Subject: RE: [EXTERNAL] 1 Santa Rosa Avenue Project

RE: 1 Santa Rosa Avenue Concept Design Review Comments

Subject: 1 SR Ave – DRB item for May 21st

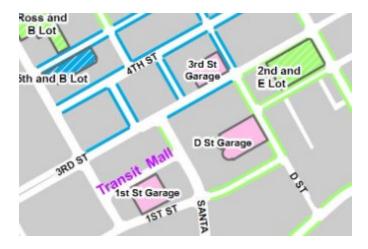
My answer to your question "Will there still be enough parking available for the office tenants in the area after this is constructed?" is based on the assumption that you represent ownership of either the Bank of America building or the 50 Santa Rosa Avenue building, both of which are located across Santa Rosa Avenue east of the proposed project site; however, any building "across the street from 1 Santa Rosa Ave." would likely utilize available public parking in the 1St Street, D Street, or 3rd Street garages. These locations are described in the image below and more fully on the online <u>Downtown Parking Map</u>.

In early 2020, analysis of existing Downtown garage and surface lot parking supply was completed as part of the <u>Downtown Plan update</u>. The analysis provided inventory and occupancy data for all Downtown parking garages, calculated Mid-Day Utilization and Availability rates, and offered the following conclusions:

- Collectively, nearly 40% of the public garage capacity (over 1,000 spaces) in Courthouse Square is available at the mid-day peak.
- Four of the five public garages have over 100 spaces available, including D Street Garage (approximately 100) and 1st Street Garage (approximately 400)

- None of the garages reaches 80% utilization
- Of the three largest garages in the system, 1st Street Garage is only reaching 35% utilization Based upon the conclusions reached by the analysis, City Planning and Parking staff conclude that there is sufficient garage parking supply in the Courthouse Square area to support existing businesses and near-term future development projects such as 1 Santa Rosa Avenue. The proposed 1 Santa Rosa Avenue is required to provide a parking study that will evaluate proposed project parking against the project's minimum parking requirement and anticipated demand for parking taking into account proximity to employment and commercial services, as well as multi-modal transportation options such as bus, SMART train, and bicycle and pedestrian networks. The project would be required to enter into a shared parking agreement with the City.
